Central Planning Authority

Agenda for a meeting of the Central Planning Authority to be held on **May 11, 2022 at 10:00am** in **Conference Room 1038, 1st Floor, Government Administration Building, and Elgin Avenue.**

CPA/13/22

Figure 1: LIS 2018 Aerial Imagery showing application site outlined in red

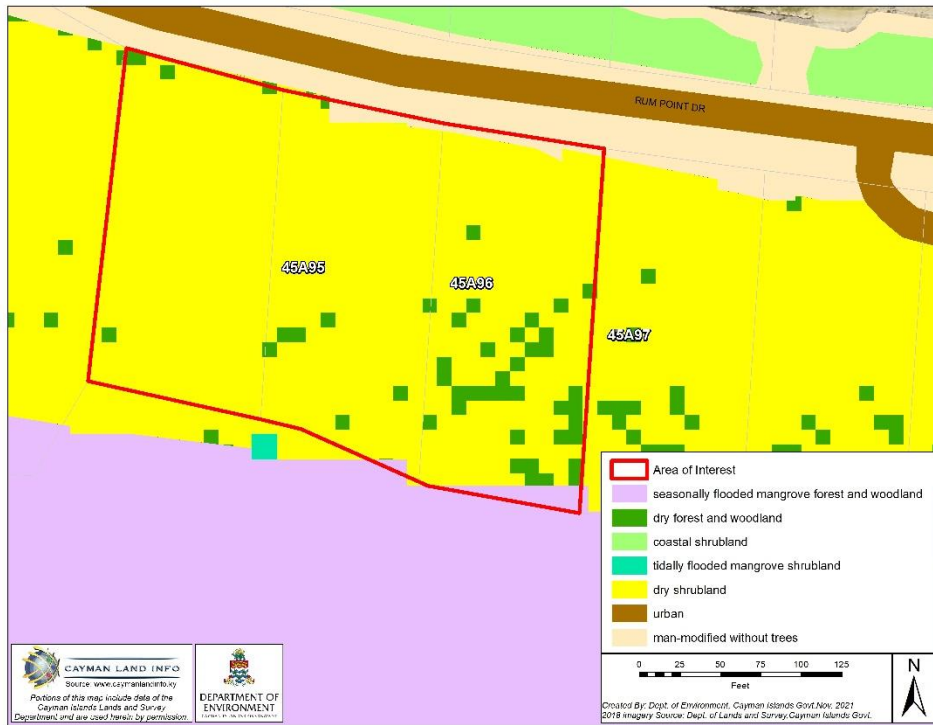
The application site comprises primary dry shrubland and forest habitat, as shown in Figures 1 and 2. Primary habitat is mature habitat in its natural state, otherwise uninfluenced by human activity where ecological processes are not significantly disturbed. These habitats are often very old, existing long before humans and may consist of many endemic and ecologically important species.

Therefore, in conclusion, without any proposal for development, the DoE recommends that the application is refused permission. Clearing of land should not occur until development has been approved and is imminent to allow sites to continue to provide habitat and ecosystem services as retention of vegetation provides benefits to the property owner and the surrounding area.

Figure 1: LIS 2018 aerial imagery showing the application site outlined in red.

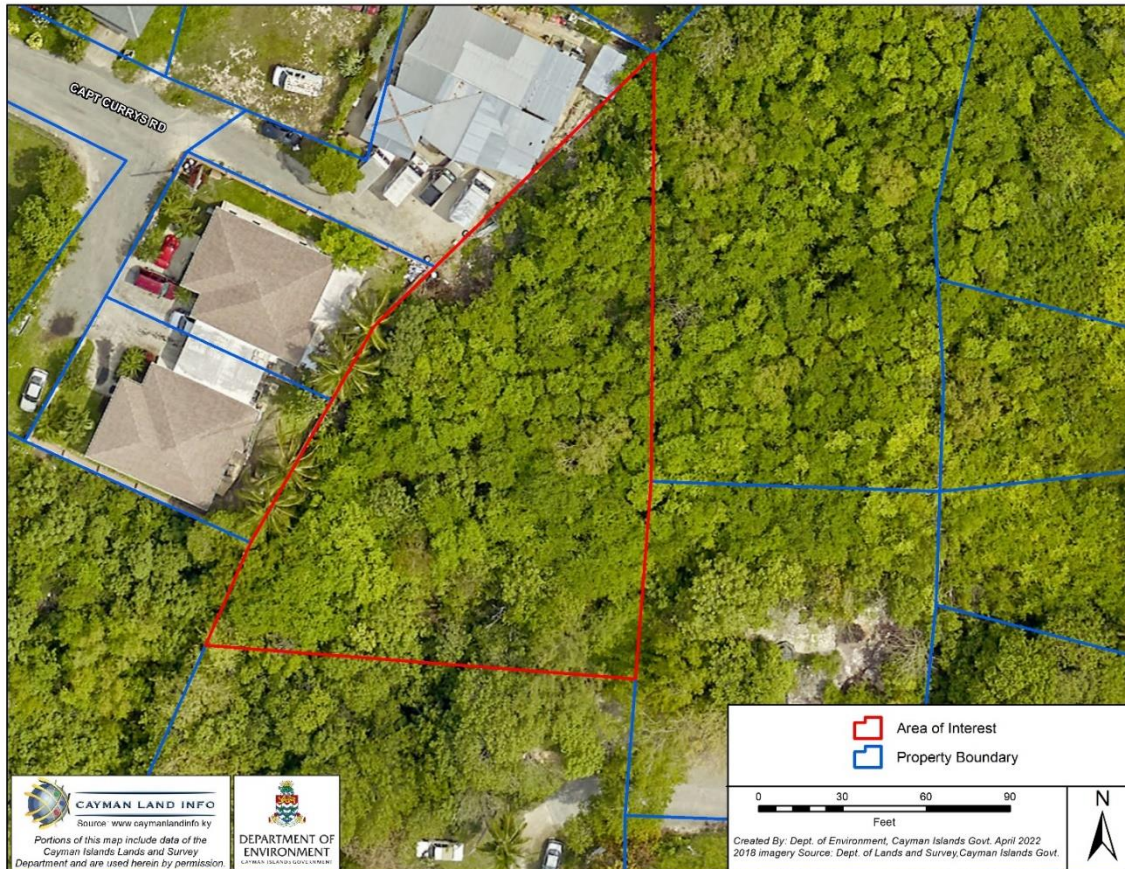
*There has been no rationale provided for the land clearing included in the applicant's submissions, therefore, the DOE considers the proposal to be speculative clearing. The DOE does **not** support speculative clearing of parcels prior to planning permission for development being granted. We recommend that applications for land clearing are presented along with the development proposal so that appropriate mitigation measures can be recommended, as there may be varying recommendations depending on the form and nature of the development being proposed. Once planning permission has been received, the DOE encourages applicants not to undertake land clearing until development is imminent to allow ecosystem services to continue to function until they are ready to begin construction. We also encourage applicants to retain as much native vegetation as possible to incorporate into the landscaping scheme. Native vegetation is best suited for the habitat conditions of the Cayman Islands, requiring less maintenance and less supplemental*

As there has been no justification submitted for the land clearing, the DOE recommends that the application is refused or deferred until a proposal for the development or use of the land has been applied for and planning permission has been granted. No clearing should take place until planning permission for land clearing, site works or development has been granted and those works are imminent.

Figure 2: A plan extract showing the unpermitted seawall, highlighted in yellow, on the submitted proposal plans (Dart, 2022).

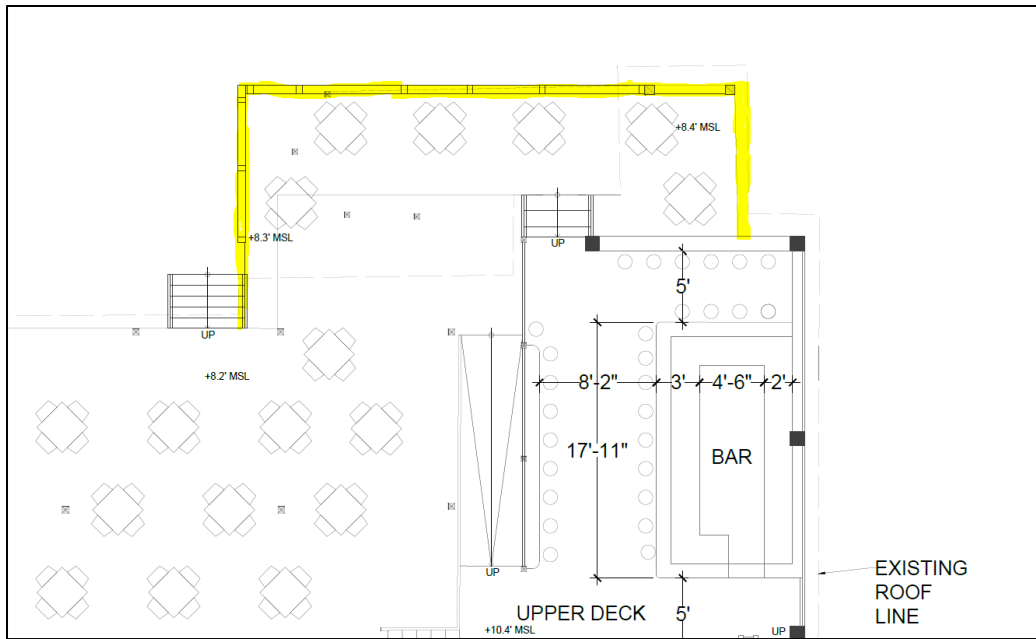
It is well-documented that hard structures, particularly those such as seawalls, that are built on a section of beach where waves can impact them cause the reflection of wave energy and the erosion of sand from the coastline seaward of them. Seawalls on beach coastlines should be located as far landward and as close to the structure they are protecting as possible to reduce the risk of direct wave impact and reflection. It is important to also highlight that setbacks seek to provide protection to properties against these inevitable effects of climate change such as coastal flooding and erosion by ensuring that hard structures are not located in an area susceptible to these hazards. The size of the parcel is sufficient to allow for the development to be located much further inland and in a way that would allow the coastal setbacks to be met.

For reasons outlined in this review, the DOE does **not** support the granting of a variance in the coastal setback, based on the current design of the proposed development and recommends the **refusal** of this application. We **strongly** recommend that the opportunity be taken to revise the site layout to meet the current Development & Planning Regulations (2022), improve the structure's climate-resiliency, increase the area of beach available for turtle nesting and meet the development intentions set out in the draft National Planning Framework (2018).

1. The applicant shall submit a revised plan removing the seawall, deck and seating area from the area surrounded by the unpermitted seawall on the beach.
